Re: AO 2024-24, Title 21 Parking and Site Access Clean-Up Text Amendments

Memo Response to AO 2023-50 and Clean-Up Ordinances

Subject: AO 2024-24 Title 21 Parking and Site Access Clean-Up Text Amendments

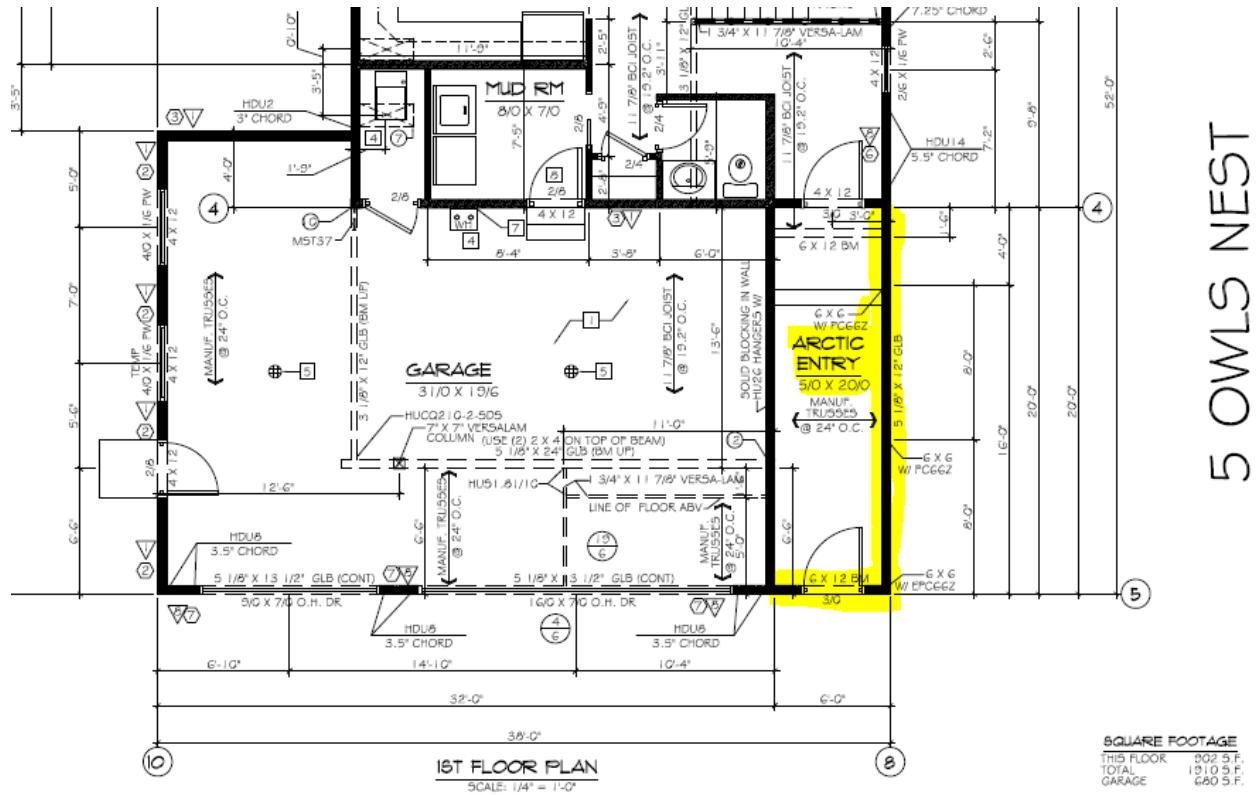
As you can see in the photo this home features a front porch with a post and roof above that are in line with the front of the garage. This home was held up during a recent zoning plan review because it did not meet the MOA planning staff's interpretation of Table 21.07-3 C. In any other section of Title 21 a covered deck is treated as part of the building but for some reason Planning staff chose to ignore the front porch or even the second floor above and measured the standard below in relation to the wall with the front door.

My first response to this initial plan review comment was to argue that the building did meet the code. Then the MOA held an internal meeting with Senior Staff from Long Range Planning to establish the interpretation of the department. I was told the garage would be measured from the wall containing the front door, which still confuses me but also wrecks the most havoc on the community.

Get ready, this is where things get weird. I then added walls to my front porch to create a long dark tunnel where the friendly front porch used to be and my permit was approved. The result is a less interesting building with less building articulation that costs more money. WINNING!!!

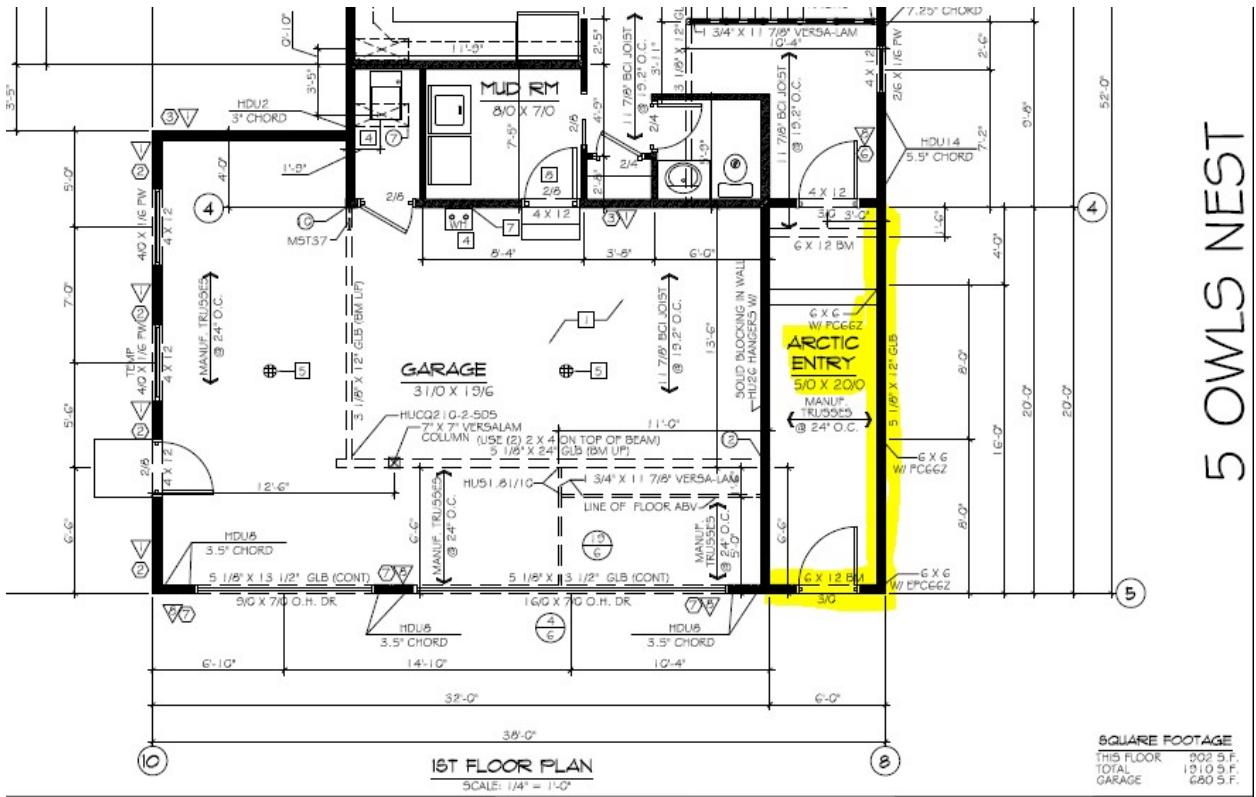
As you can see in the photo this home features a front porch with a post and roof above that are in line with the front of the garage. This home was held up during a recent zoning plan review because it did not meet the MOA planning staff's interpretation of Table 21.07-3 C. In any other section of Title 21 a covered deck is treated as part of the building but for some reason Planning staff chose to ignore the front porch or even the second floor above and measured the standard below in relation to the wall with the front door.

My first response to this initial plan review comment was to argue that the building did meet the code. Then the MOA held an internal meeting with Senior Staff from Long Range Planning to establish the interpretation of the department. I was told the garage would be measured from the wall containing the front door, which still confuses me but also wrecks the most havoc on the community.

Get ready, this is where things get weird. I then added walls to my front porch to create a long dark tunnel where the friendly front porch used to be and my permit was approved. The result is a less interesting building with less building articulation that costs more money. WINNING!!!
